Subject: Dawn Subdivision

REVIEW COMMENTS

FILE #PP-96-47

TITLE HEADING: Dawn Subdivision

SECTION A - A₁

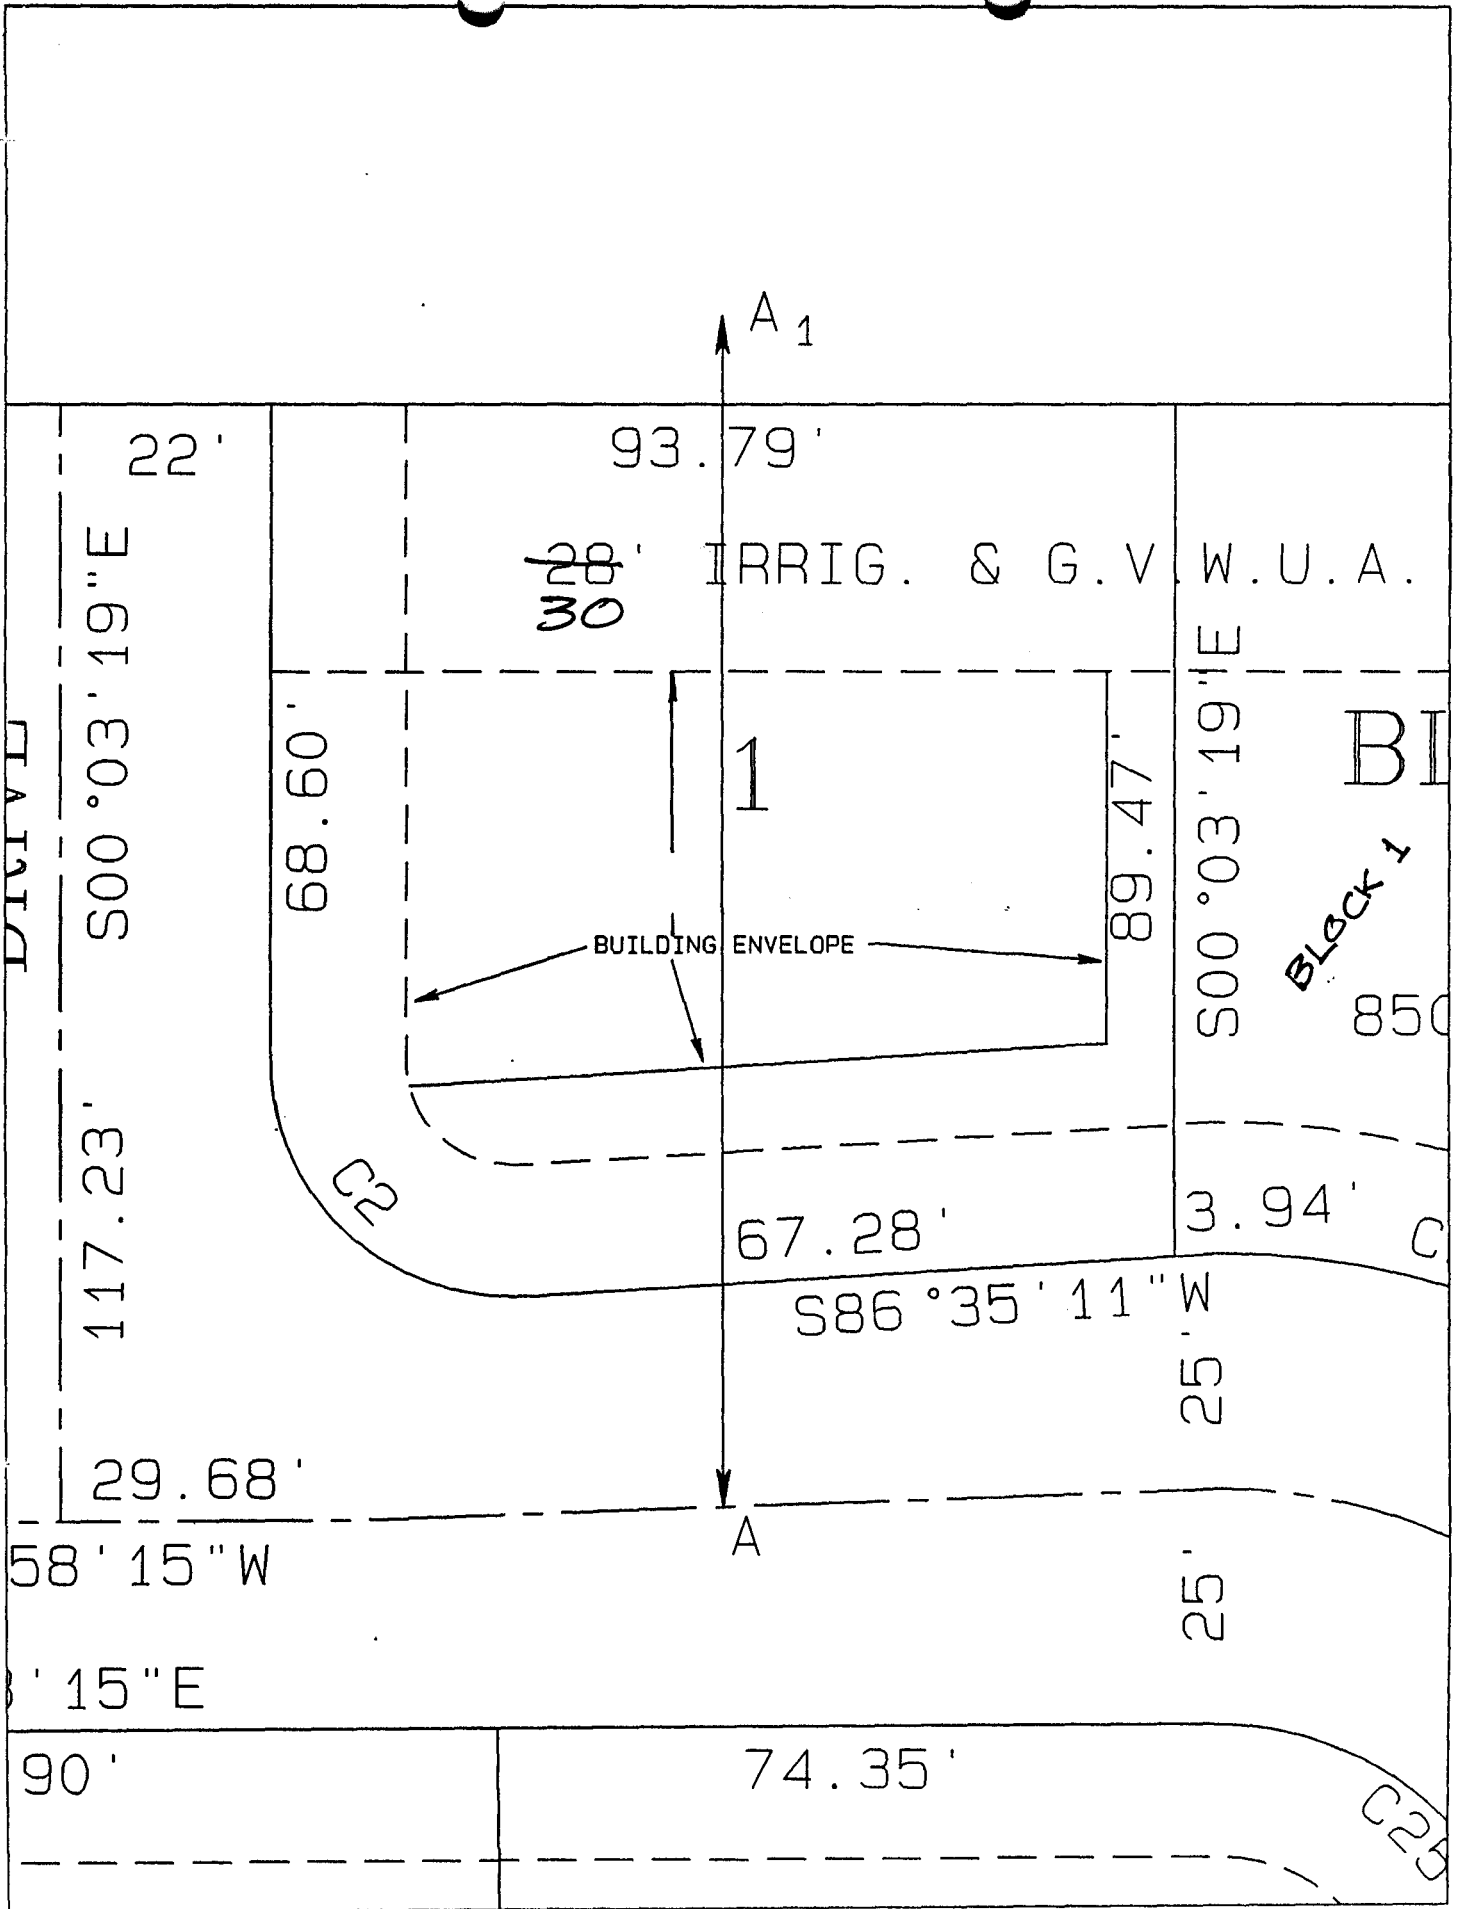
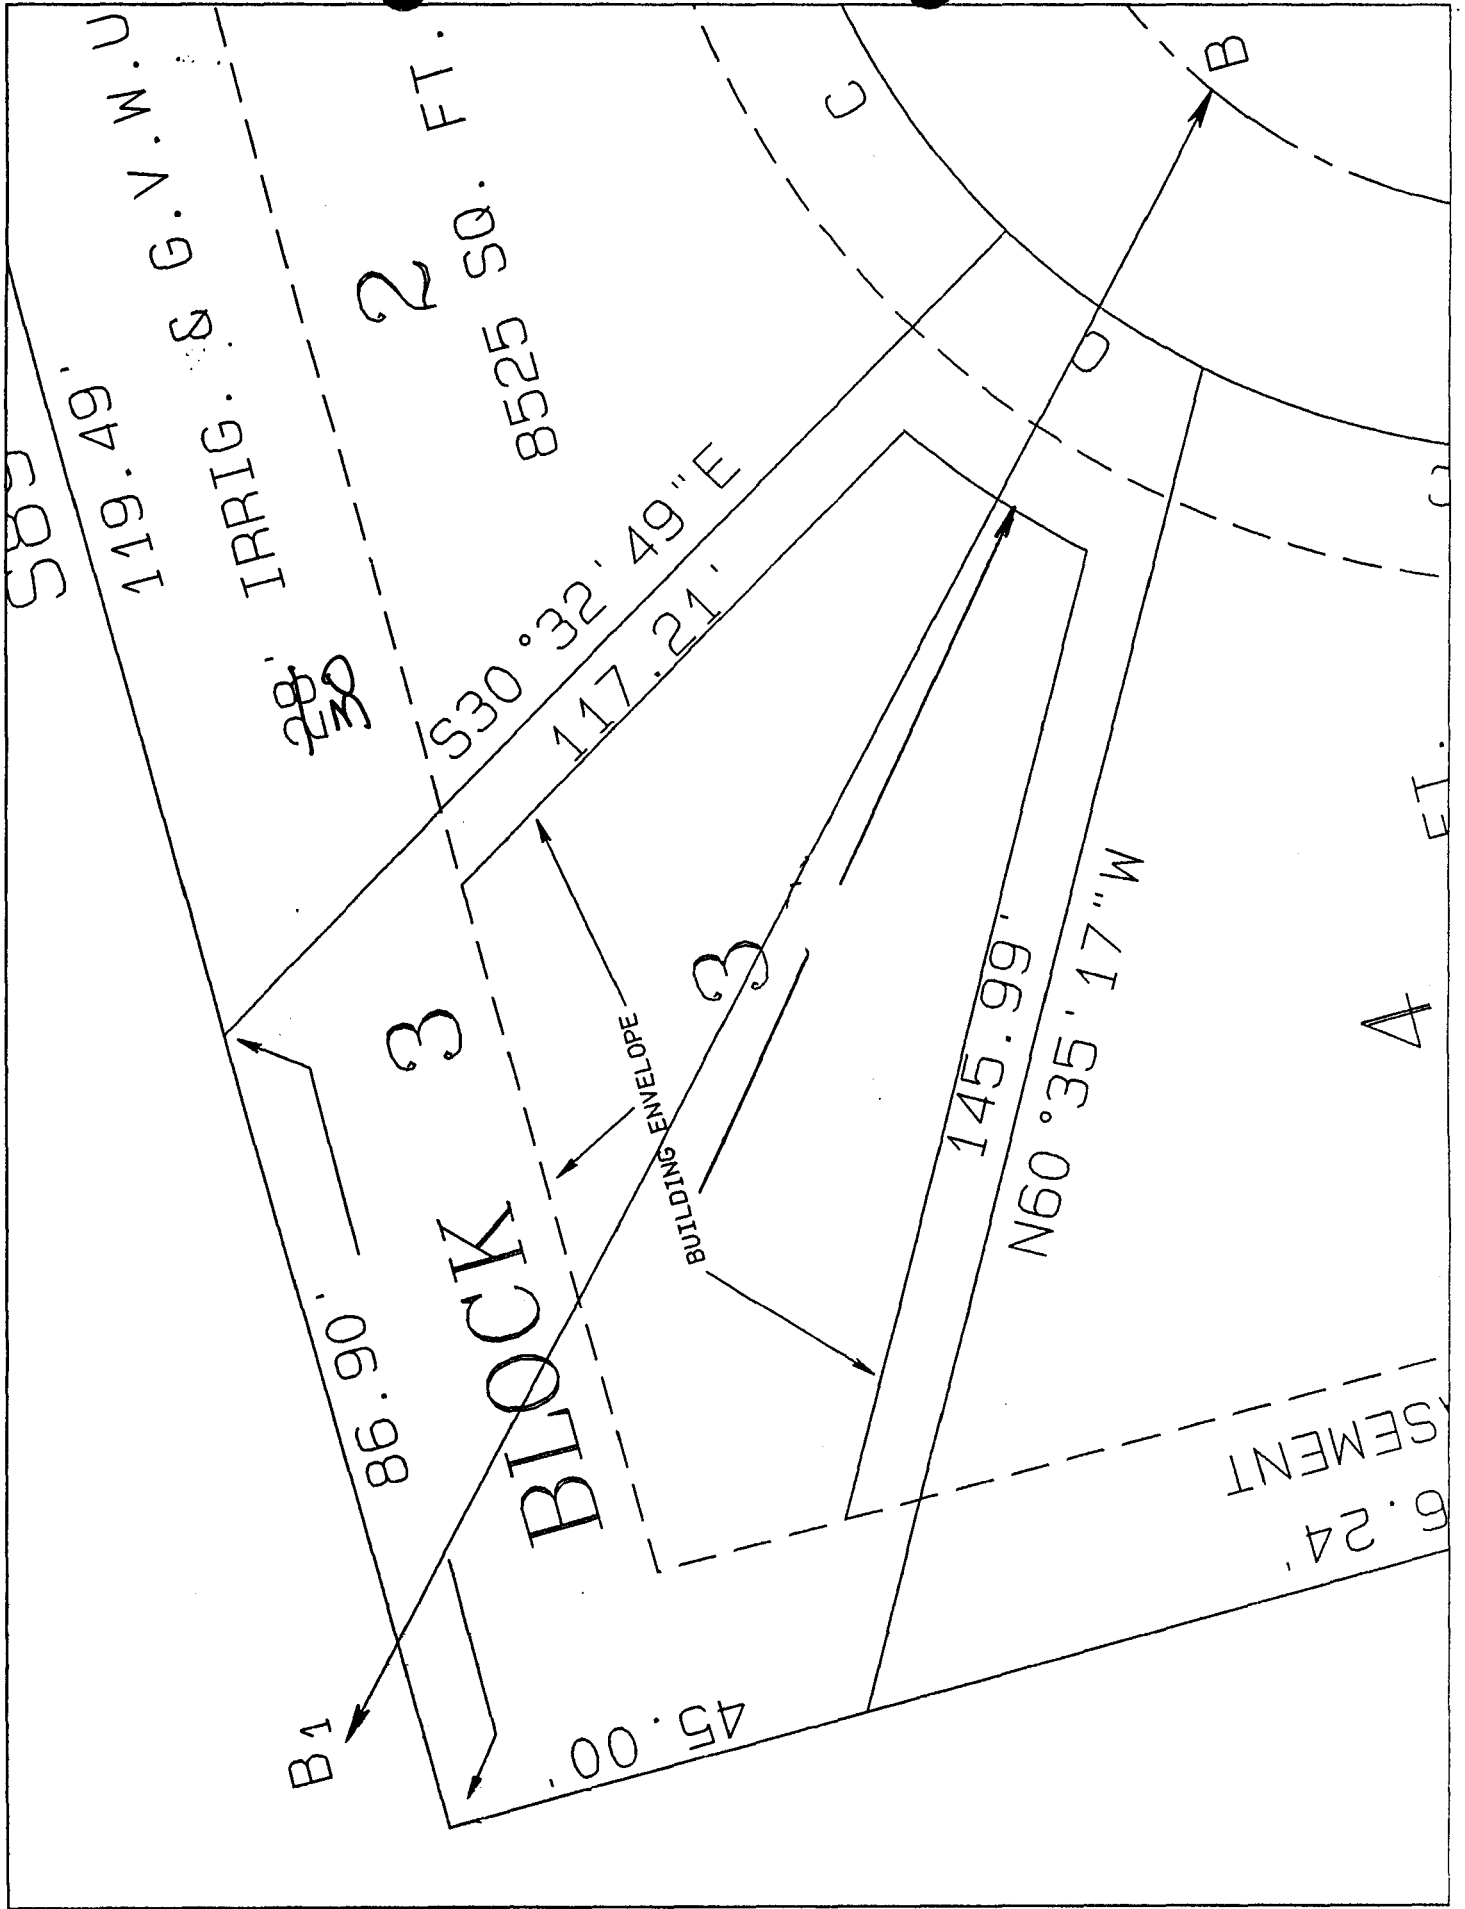
I met today and reviewed the above profiles with Mr. Dick Proctor of GVVUA, and he has verbally approved a 30 ft. easement for the north side of the plat. The final plan submitted shows 28 ft. and will need to be revised to 30 ft. Mr. Proctor will of course hopefully reiterate his approval when he submits his review comments for the Dawn final plan.

DAWN SUBDIVISION PRELIMINARY PLAN

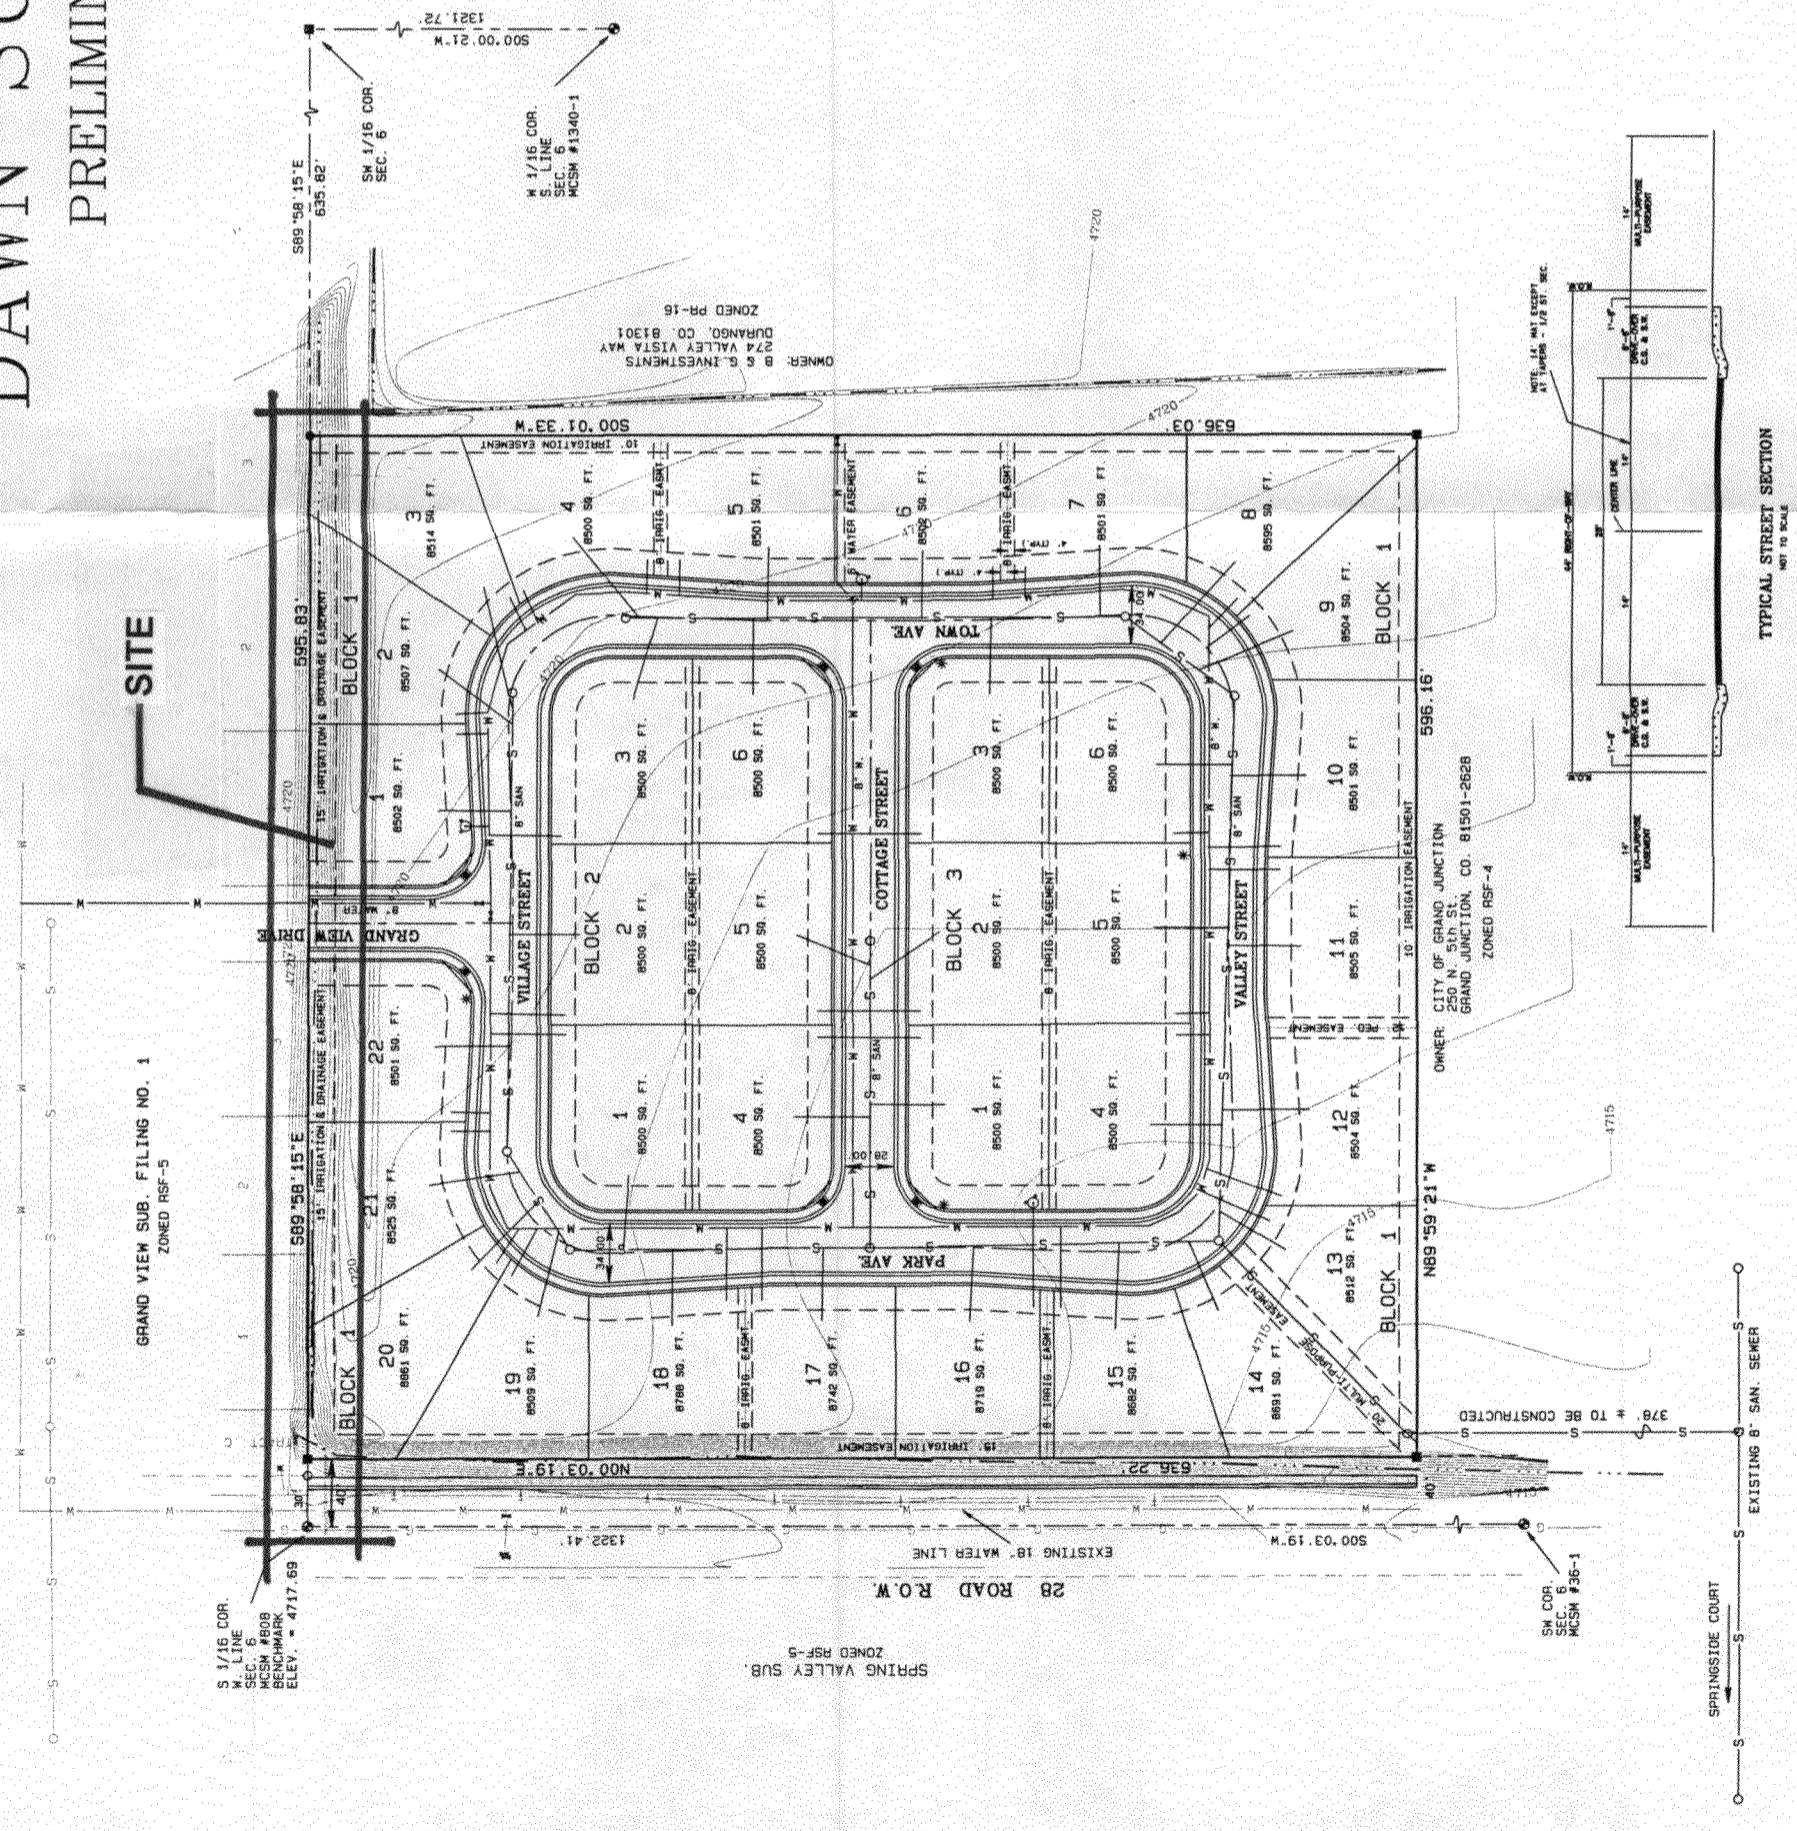
2. The plan submitted shows 40' of right-of-way on 28 Road and the proposed detention facility in the right-of-way. Please verify the existing right-of-way width. 28 Road is classified as a collector, which requires 60' of right-of-way and 44' of pavement width.

3. The preliminary drainage report states swales will be used to convey stormwater. The plan shows what looks like a storm drain pipe which does not quite reach the ditch. A pipe, properly sized, will be required. There are too many maintenance problems associated with swales in easements located between two houses.

6. What is the depth of the proposed sewer connection? The ditch along 28 Road appears to be about 10' deep according to the contours shown on the plan. Is the

3. Please not all lot sizes on plan in square feet and place dimensions on the lots. The minimum lot area in the RSF-4 zone is 8,500 square feet. Some lots appear smaller than this, particularly those on the interior of the site.

Developers Response: County had required it from the church and is already done.

Developers Response: OK

Developers Response: Revised Drawing

Developers Response: Revised, see plat
